Spring Trade Ltd. (9522)

ACCORD
on Fire and Building Safety in Bangladesh

Identified Priority 1 Concerns

Typical column to be checked

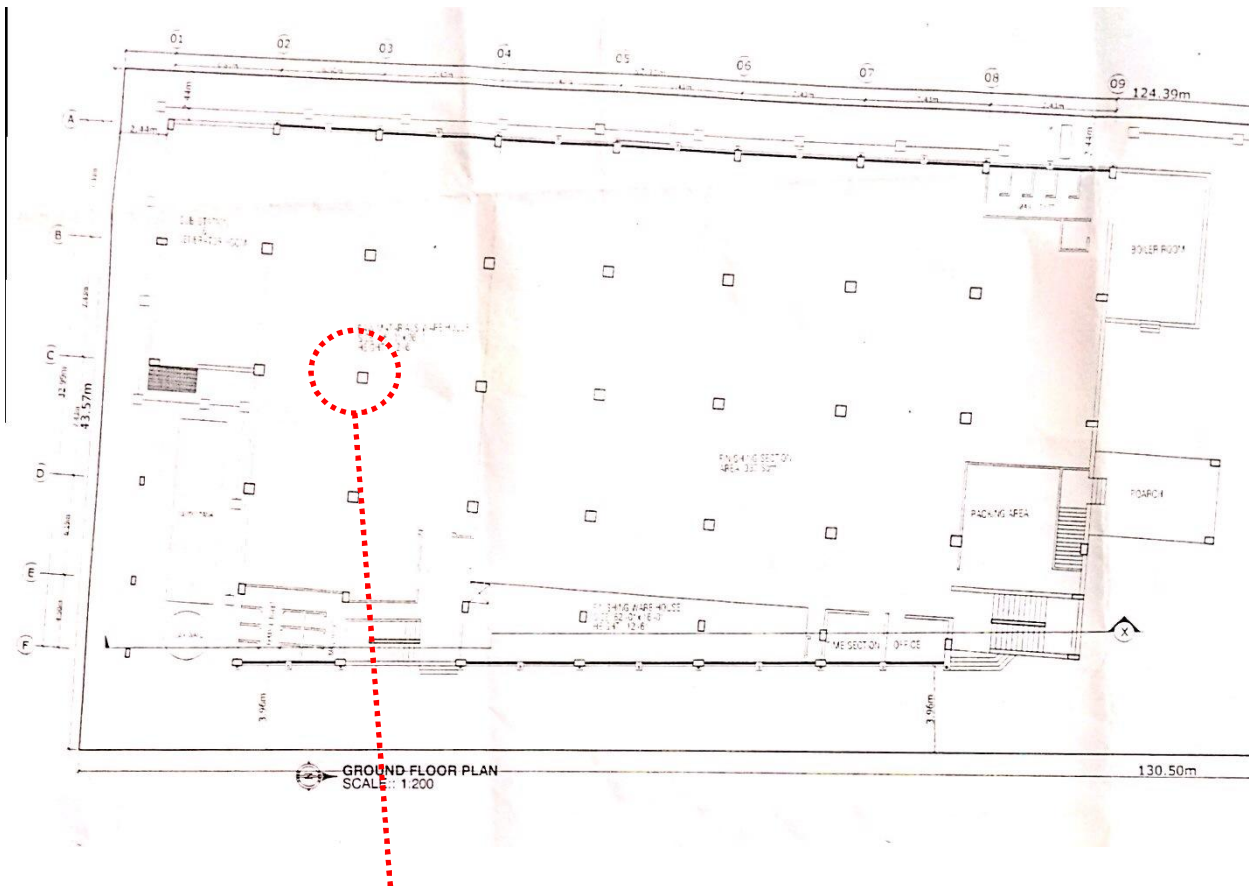
1st Priority 1 Concern

Based on the load rundown analysis with the agreed minimum design live load assignment, the column at the circled area has been found to be significantly insufficient in carrying the dead and live loads. The working stress is just a fraction above being rated with a 'red' warning, giving a firm 'AMBER' warning instead. The building was constructed with brick aggregate and high-yield re-bar.

ITEM 1: (1st Priority 1) Columns in Building 1 exhibit insufficient capacity under current building floor loads.

Preliminary load take-down calculations suggest that the typical columns in two buildings are very close to having a 'red' warning. The typical columns possess very little spare capacity.

- Carry out a full Detailed Engineering Assessment of the entire building including any intrusive testing required.
- Carry out full survey of all structural elements to check the loading capacity of the overall structural system.
- The Factory Engineer to review design, loads and columns stresses in entire building in accordance with BNBC regulations.

- Provided loading plan must be strictly maintained.

Typical column to be checked. Two buildings has been designed in the same way. Thus, the results are very similar for all typical columns

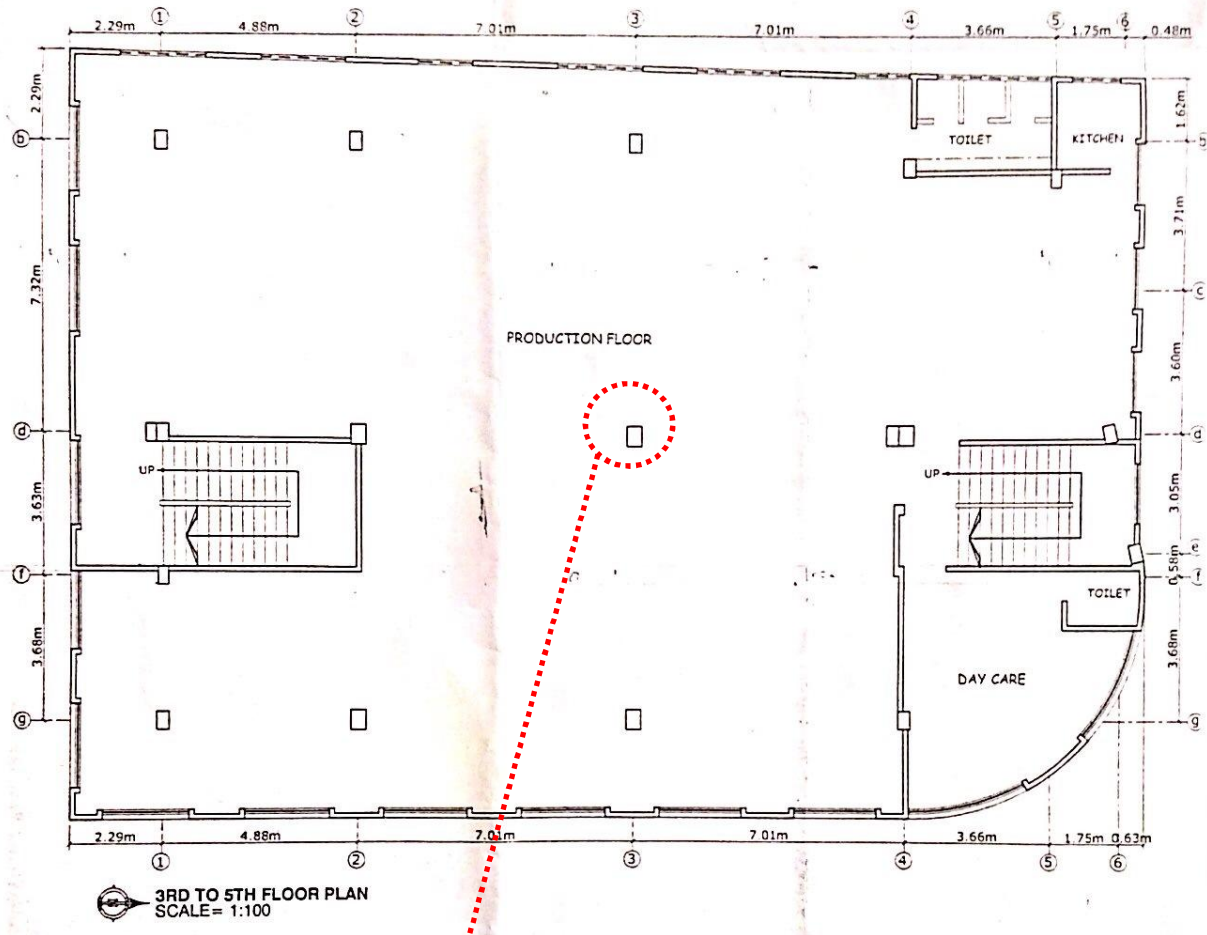
2nd Priority 1 Concern

The same procedure is applied for the typical columns in building 2 for checking the working stress. The column at the circled area has been found to be significantly insufficient in carrying the dead and live loads. The working stress is just a fraction above being rated with 'red' warning, giving a firm 'AMBER' warning. The building was constructed with brick aggregate and high-yield re-bar.

ITEM 2: (2nd Priority 1) Columns in Building 2 exhibit insufficient capacity under current building floor loads
